Access Compliance Report

Public Rights-of-Way

(Curb Ramps)

Intersection ID: 10027139	Main Street: GARLAND_CT	Cross Street: N/A	Location: N
ADA ID: 6BA66B85E687	Ramp Type: Perp	Initial Pass/Fail: Fail	Overall Compliance: No
Severity Score: 8.75			
Codes/Mitigation Info/Possible Solution		Field Measurements/Component Compliance

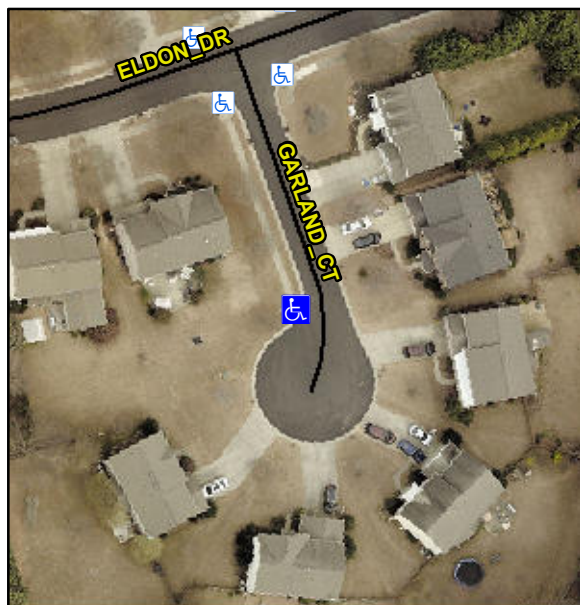
Not Found, R304.5.1

Compliance	Description	Data	Compliance	Description	Data
N/A	Ramp Length (in)	47.0	Yes	Ramp Slope (%)	6.9
No	Ramp Width (in)	47.0	Yes	Ramp XSlope (%)	0.6
N/A	Flare Type LT	N/A	N/A	Flare Type RT	N/A
N/A	Flare Slope LT (%)	N/A	N/A	Flare Slope RT (%)	N/A
N/A	Flare Traversable LT?	N/A	N/A	Flare Traversable RT?	N/A
N/A	Landing Length (in)	N/A	N/A	DWS Provided?	N/A
N/A	Landing Width (in)	N/A	N/A	DWS Contrast?	N/A
N/A	Landing Slope (%)	N/A	N/A	DWS Length (in)	N/A
N/A	Landing X Slope (%)	N/A	N/A	DWS Full Width?	N/A
N/A	Landing Curb? (Y/N)	N/A	N/A	DWS Offset (in)	N/A
N/A	Shared Landing?	N/A			
N/A	Gutter Ponding?	N/A	N/A	Gutter Slope (%)	N/A
N/A	Gutter Lip Ht (in)	N/A	N/A	Gutter X Slope (%)	N/A
N/A	Painted X Walk1?	No	N/A	Painted X Walk2?	N/A
	X Walk 1 Direction	To SE		X Walk 2 Direction	N/A
N/A	X Walk 1 Width (in)	N/A	N/A	X Walk 2 Width (in)	N/A
	X Walk 1 Slope (%)	5.9		X Walk 2 Slope (%)	N/A
	X Walk 1 X Slope (%)	0.1		X Walk 2 X Slope (%)	N/A

Remove & Replace Entire Ramp.
